DESIGN REVIEW RECOMMENDATION

256-260 Elm Street

May 26, 2022

Façade Evolution

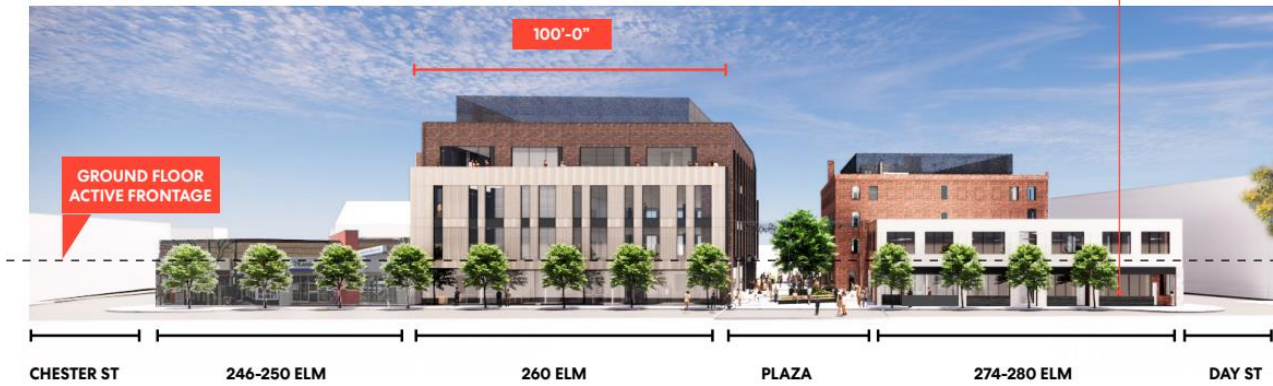
- The Commission requested the building design on the ground-floor be further integrated with the public realm on Elm Street to create a more welcoming retail space.
- The rear and front façade of the building design be differentiated. The rear façade on Herbert Street should be reduced in scale.
- The band that separates the ground floor from the second floor and wraps around the building should not be continuous and further developed to allow for individual retail storefront signage.
- The façade's terracotta cladding should be further developed to read as a screen.

- On the rear façade facing Herbert Street, investigate the terracotta cladding coming down towards the ground level.
- Study whether a granite base at the base of the piers would work for this design.

On April 12, 2022, the Commission voted unanimously (5-0) to recommend approving façade option 3 with the terracotta cladding. On April 26, 2022, the Commission voted unanimously (4-0) that the applicable design guidelines (Commercial Core 4) were satisfied. The Commission voted unanimously (4-0) to incorporate additional design
